Design Review Report

Land North of J33 M4 – Phase 5B

DCFW Ref: N308

Meeting of 21st May 2026

Site Layout Plan

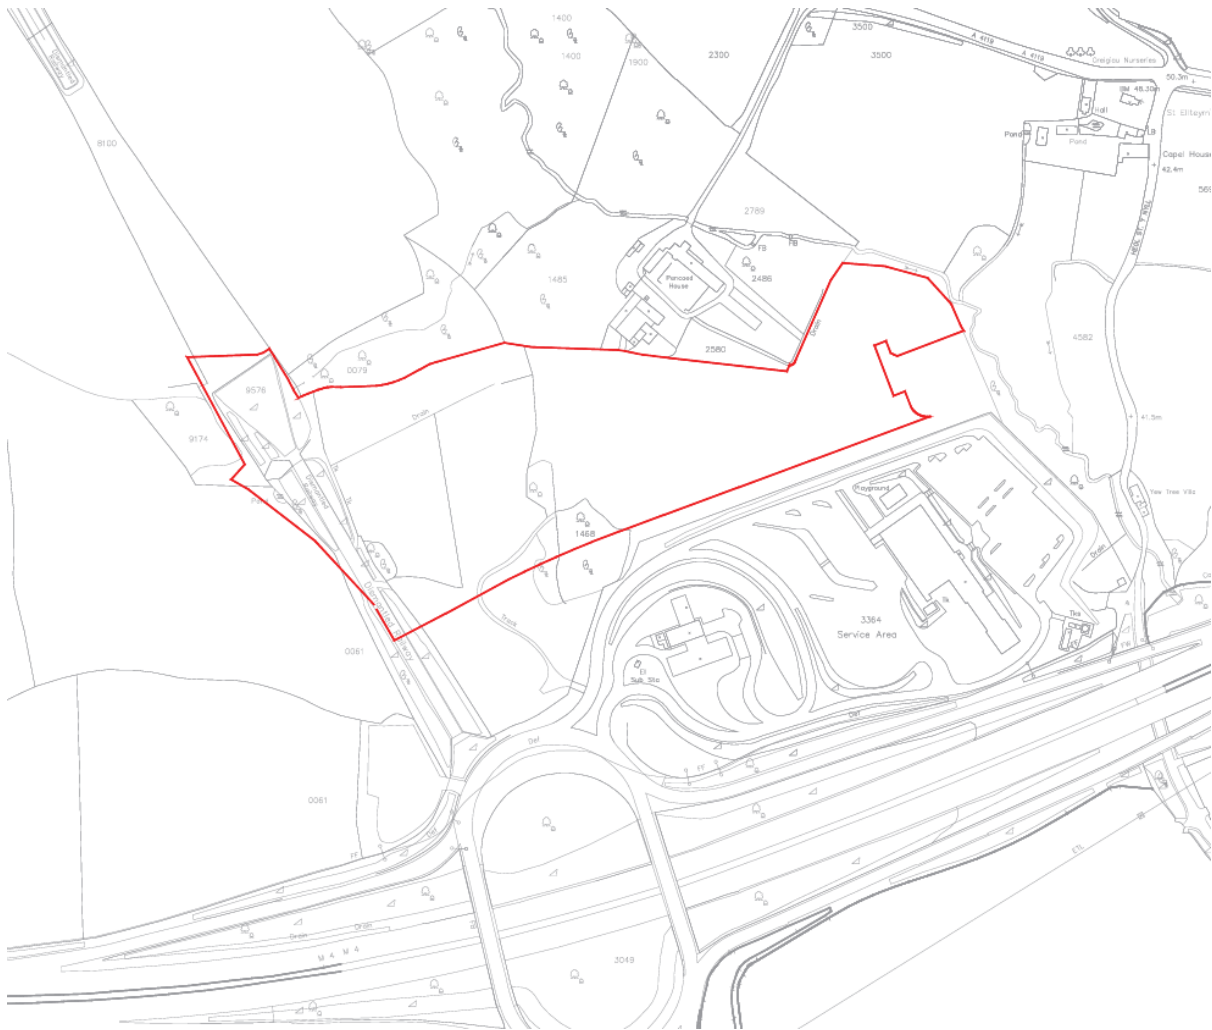
The current layout, street design and housing arrangement create a relatively standardised suburban character that risks feeling placeless and insufficiently responsive to the site's landscape setting, surrounding context and wider placemaking ambitions.

The amount and arrangement of parking creates challenges in several locations and contributes to a vehicle-dominated environment. This results in several poorly resolved areas throughout the site, including rows of double parking spaces between buildings, parking courts with limited natural surveillance, large areas dominated by vehicles, and cul-de-sacs that limit connectivity, movement choice and relationship to the wider development. These elements collectively suggest that parking provision and highway-led design approaches are exerting too great an influence over the structure of the development.

The current street layout and housing arrangement create a uniform and standardised environment across much of the site. The submitted material does not demonstrate a sufficiently varied or responsive approach to street design, landscape structure and building arrangement, resulting in limited distinction between different parts of the development.

The original concept proposed a central green space with significant tree planting. The current proposals instead create a small triangular space that lacks the enclosure, purpose and relationship with surrounding buildings needed to function successfully as a meaningful focal point for the community.

The affordable housing is concentrated within the far edge of the site in an area with a constrained and awkward site geometry, creating a number of challenges relating to layout, parking and integration with the wider development.

The current design does not successfully resolve these conditions. In particular, the parking and green spaces positioned behind gardens lack natural surveillance and clear purpose, creating potential concerns regarding safety, stewardship and long-term management. Similarly, the attenuation pond has limited relationship with the surrounding homes and lacks strong overlooking, frontage and integration with the residential environment. The layout and arrangement of buildings should respond more positively to these spaces so that they contribute more meaningfully to the character, amenity and identity of this part of the development.
